SOUTH DAKOTA PUBLIC UTILITIES COMMISSION

CASE NO. EL05-022

CONSTRUCTION OF THE BIG STONE II PROJECT

PREFILED REBUTTAL TESTIMONY

Exhibit 1-2
 PROJECT SITE
 Big Stone II Project
 Big Stone II Co-owners
 Revised June 2006

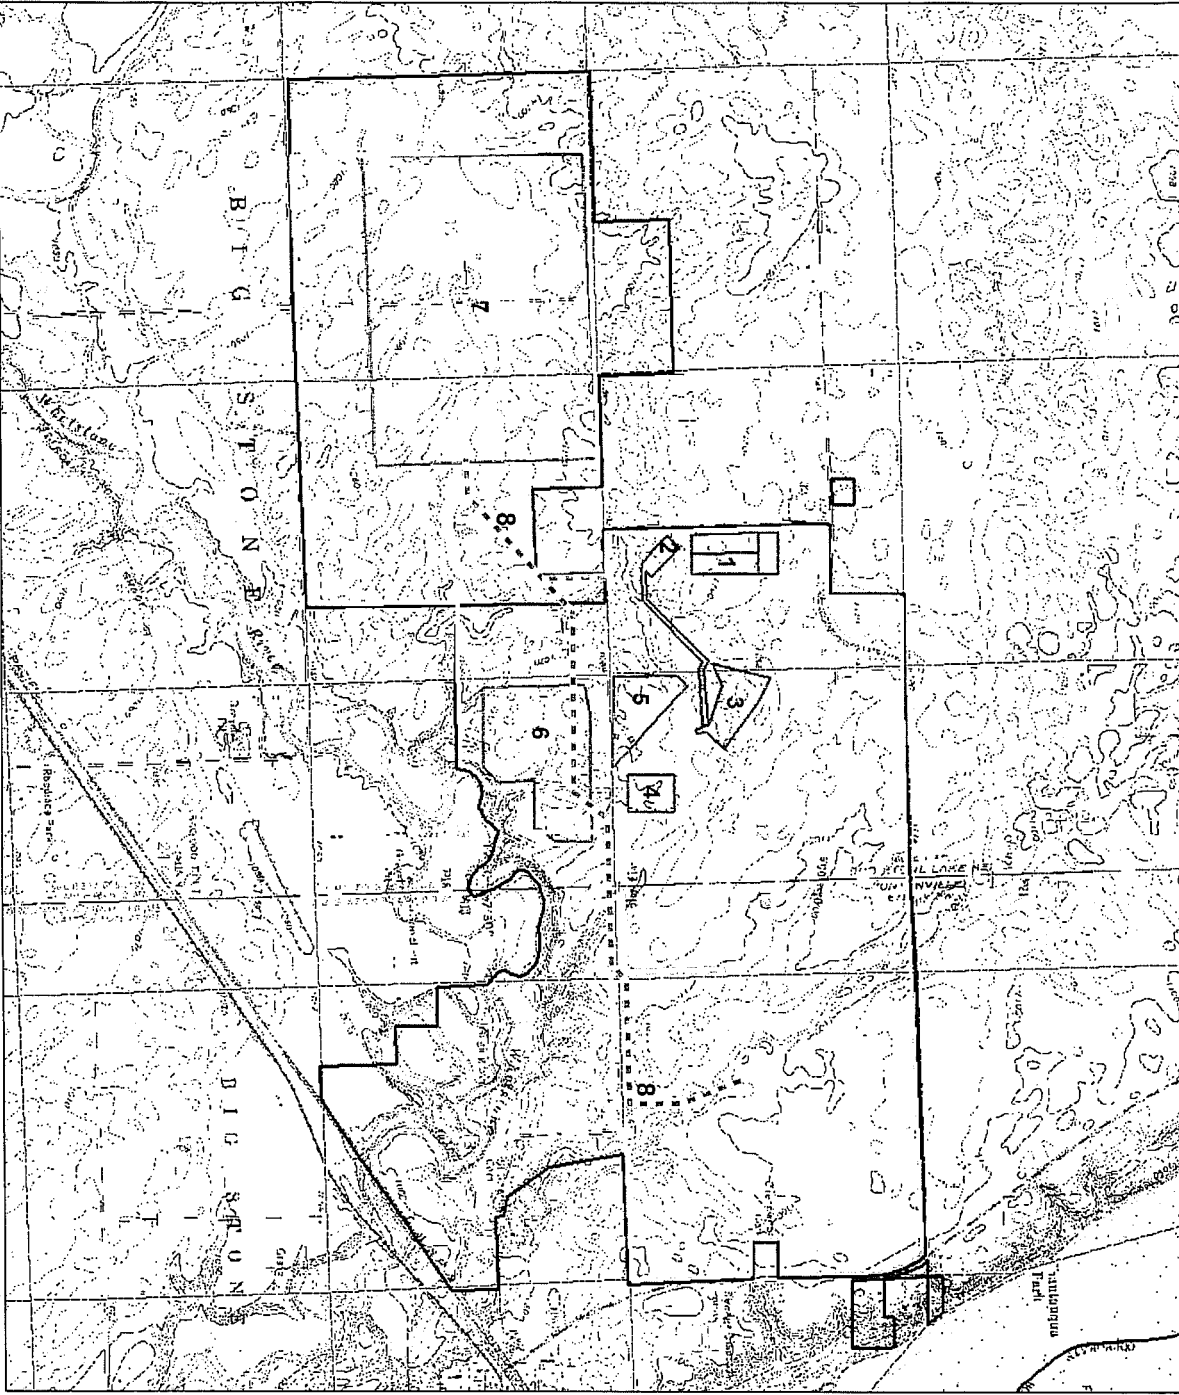
12 The Applicants have taken options on or purchased five additional pieces of property that
 13 will increase the plant site buffer area. The residence closest to the plant site, which is north and
 14 west of the plant, has been purchased. The Applicants also have purchased or taken options on
 15 additional properties to the north and west of the proposed water storage ponds, and taken an
 16 option on one of the residents to the south of the water storage ponds. The Project site, including
 17 these additional properties, is shown on Applicants' Exhibit 33-A.

19 The Applicants plan to have an enlarged construction lay down area with a railspur
 20 leading from the plant's main railspur into the lay down area to facilitate delivery of material by
 21 rail. The expansion of the lay down area would occur on additional property to the east. All of

1 the lay down area would be returned to its original state following construction. The lay down
 2 area is shown on Applicants' Exhibit 33-A.

Exhibit 2-2
 POWER PLANT SITE
 Big Stone II Project
 Big Stone II Co-owners
 Revised June 2006

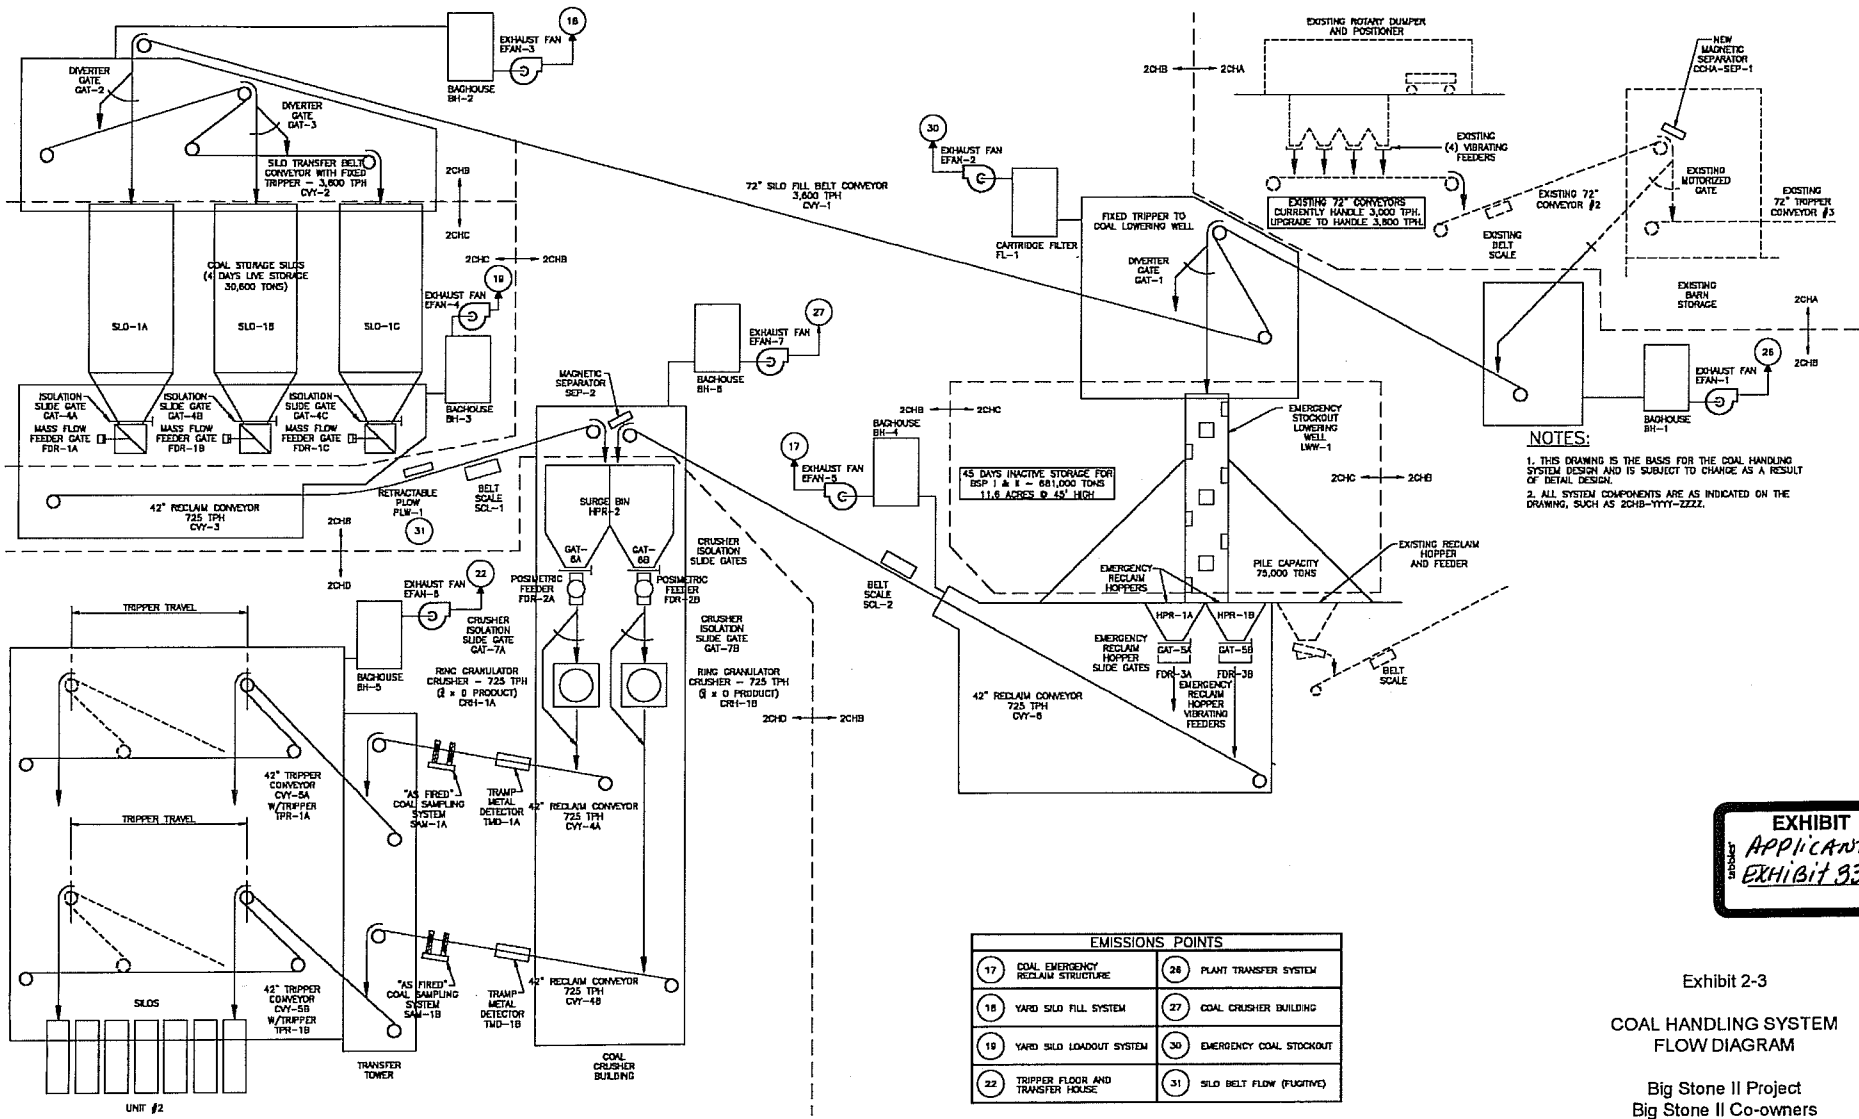
4 A revised site layout for the plant is attached as Applicants' Exhibit 33-B, and shows the
 5 exact size and location of the plant structures. The changes are minor and are confined to the
 6 areas adjacent to the existing plant structures.

8 Because of revisions to the higher National Fire Protection Code, we are evaluating
 9 whether or not two additional diesel powered booster fire pumps will need to be added. One is
 10 for the main boiler building and the second is for the coal silos to provide enhanced water
 11 pressure at the elevated locations. The proposed locations of the fire pumps are shown on
 12 Applicants' Exhibit 33-B.

14 Because of the current water balance it may prove to be more practical to add two brine
 15 concentrators, rather than one. The final decision on the number of brine concentrators has yet to
 16 be made. If two concentrators are used, they will be located adjacent to the existing brine
 17 concentrator that is shown on Applicants' Exhibit 33-B.

COAL HANDLING SYSTEM FLOW DIAGRAM

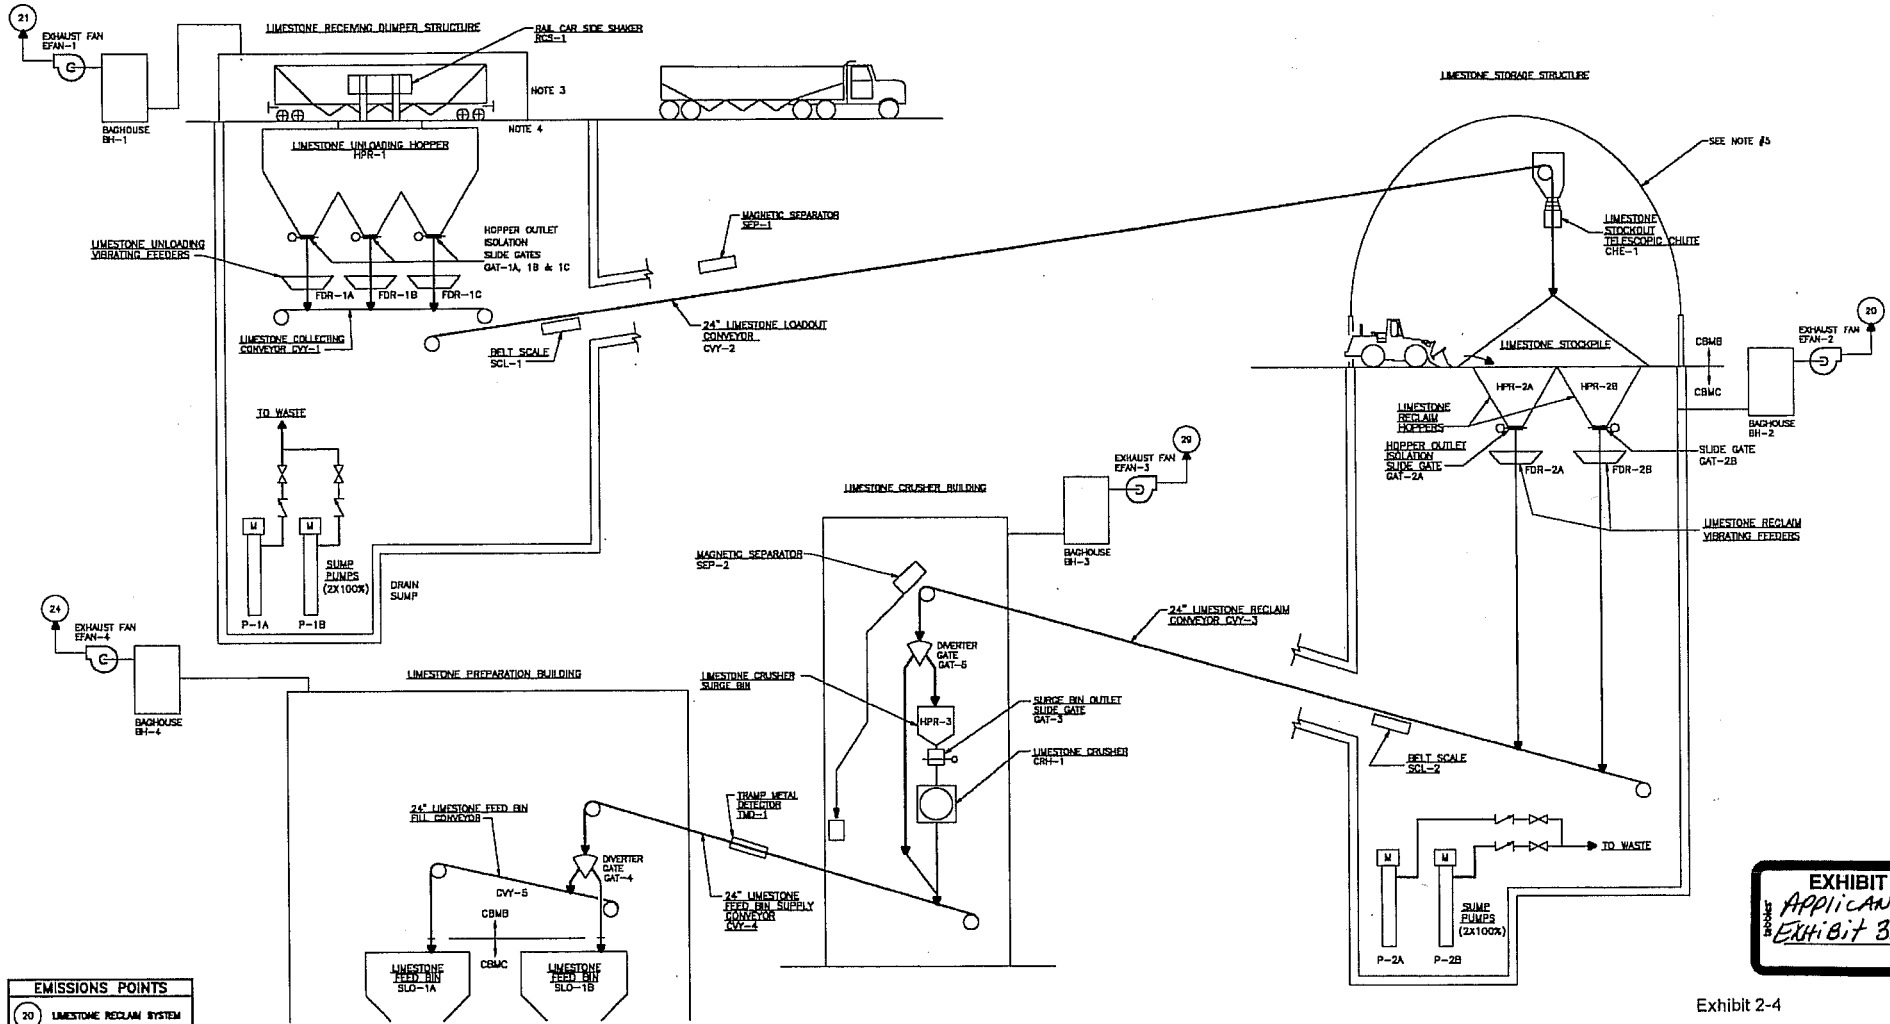
19 The original design for the coal stock out was a retractable plow and telescopic chute.
 20 We are evaluating whether to replace this with a fixed tripper and fabric filter dust collector and
 21 lowering well, as this arrangement is anticipated to provide better dust control and serviceability

1 of the coal stock out operation. These proposed facilities are also shown on Applicants' Exhibit
 2 33-C.

4 With the previous mentioned proposed change of the telescopic chute to a lowering well,
 5 the active coal stockpile capacity would change from 28,000 tons to an estimated 75,000 tons.

6 See Applicants' Exhibit 33-C.

8 A proposed retractable plow would be added to the conveyor from the storage silos to
 9 provide for emergency emptying of the silos. The location of the plow is shown on Applicants'
 10 Exhibit 33-C.

**LIMESTONE HANDLING SYSTEM
 FLOW DIAGRAM**

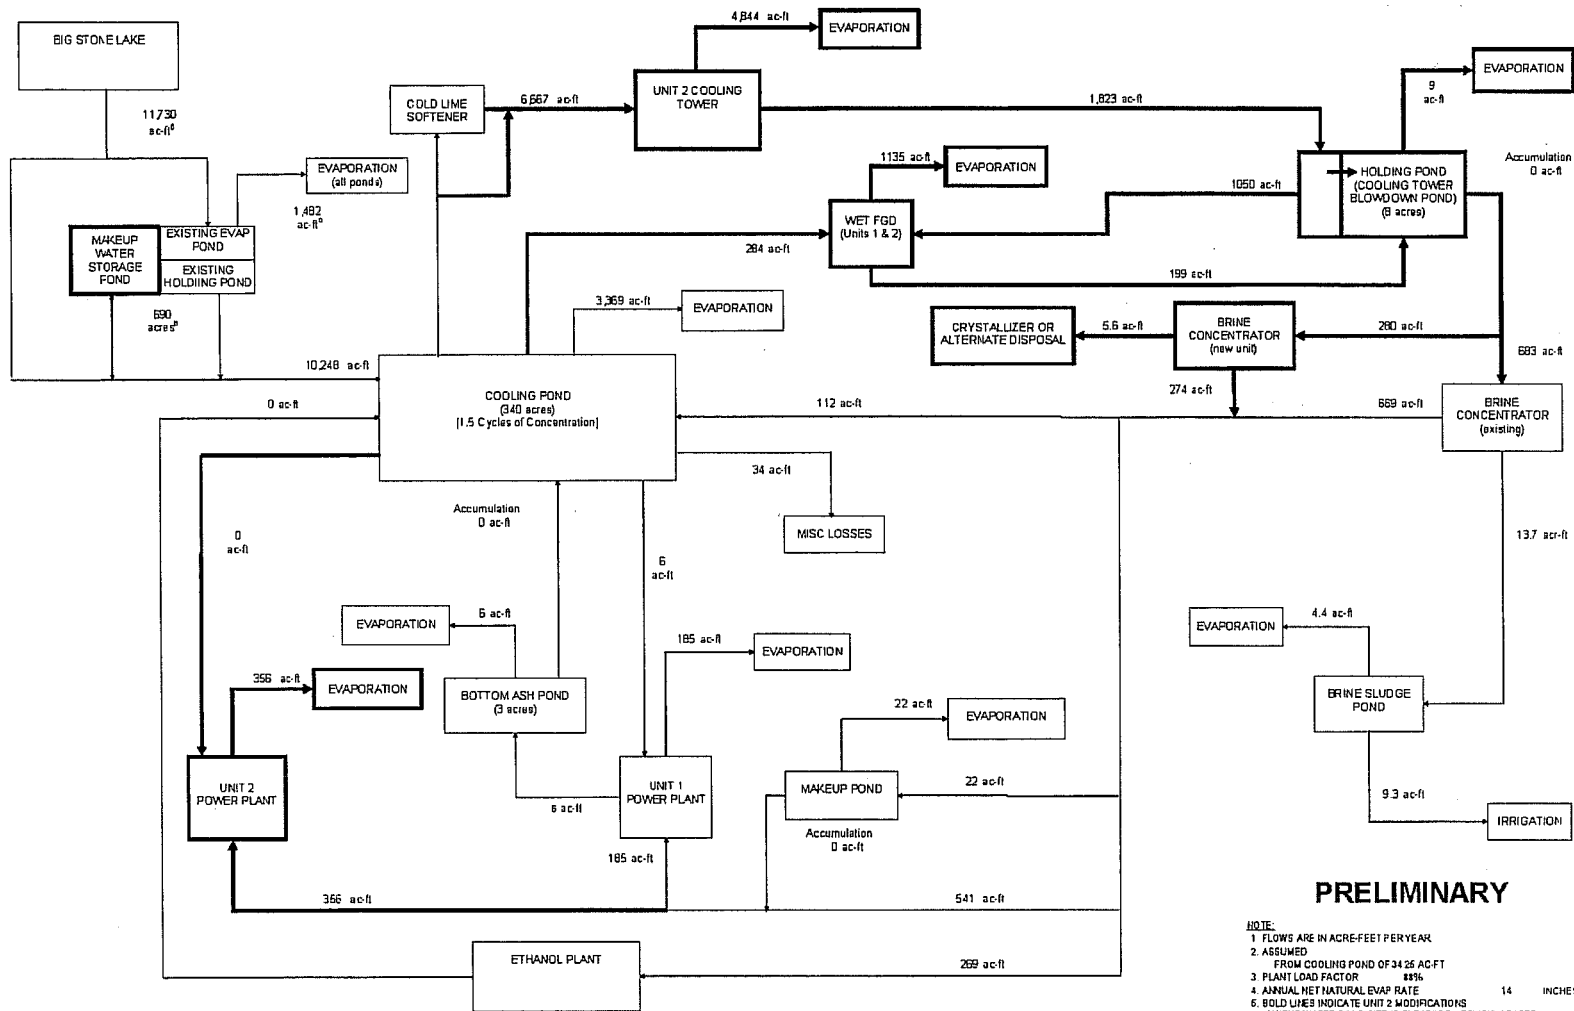
12 A proposed limestone crusher and fabric filter would be added in order for the Project to
 13 be able to receive two inch and larger crushed limestone. The proposed location of these
 14 facilities is shown on Applicants' Exhibit 33-D. The larger limestone will be less susceptible to
 15 freezing in cold weather and will allow the Applicants to utilize a larger range of limestone
 16 suppliers.

18 The Applicants propose to replace the 15,000-ton umbrella limestone storage with an
 19 8,000 ton hoop storage facility having open ends orientated perpendicular to the wind. This
 20 storage arrangement should be more cost effect and provide better dust control. A flow diagram
 21 of these facilities is found in Applicants' Exhibit 33-D.
